DESIGN STANDARDS/PRACTICE EXCEPTION REQUEST SUMMARY

Title: Hwy 628:04, Intersection Improvement, Approach Sideslopes

Memorandum (or Approval) Date: June 13, 2012 Design Exception Request Date: June 8, 2012

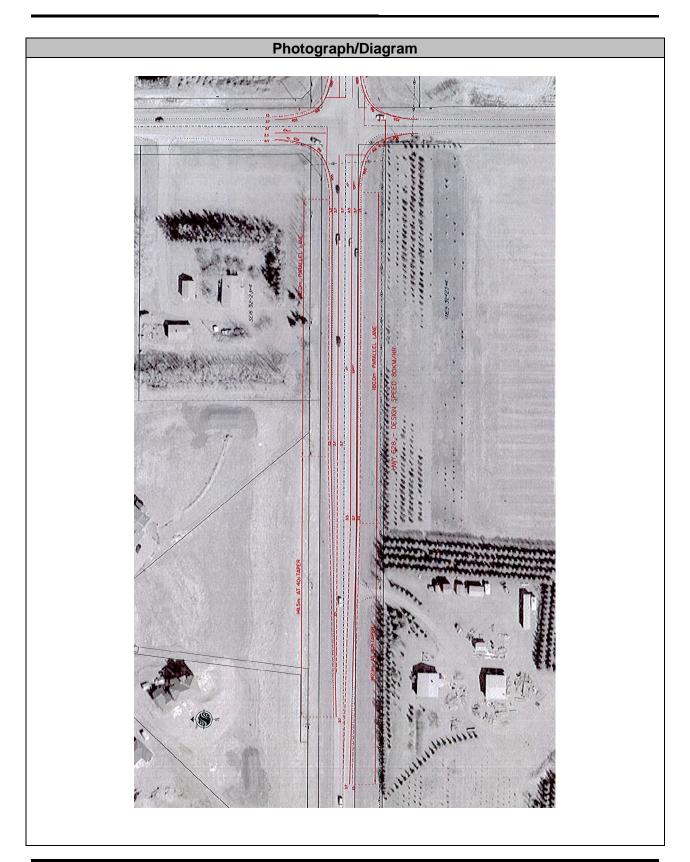
Proposed intersection improvement at Highway 628:04/Range Rd. 233. The design exception request is for a V-ditch in the SW quadrant resulting in a 4:1 sideslope approach in the SW quadrant of the intersection.

Based on the ATHGDG, Chapter G, 3R/\$R Guidelines, Table G.6.4, Suggested Approach Sideslopes for Highways Posted Speed ≥ 100 km/h, AADT > 3000 and fill height < 4m, a approach slope of 5:1 is acceptable on existing approaches for projects with a major grading component. Desirable slope on new approaches are 7:1.

- The design speed on Highway 628 is 80 km/h and the posted speed = 70 km/h.
- Traffic signals will be installed along with advance warning flashers in both directions of Hwy 628.
- Drainage flows away from the SW corner of the intersection.
- The proposed intersection is an interim stage improvement until Highway 628 is twinned in the future.

Additional Mitigation Required				
No mitigation is required.
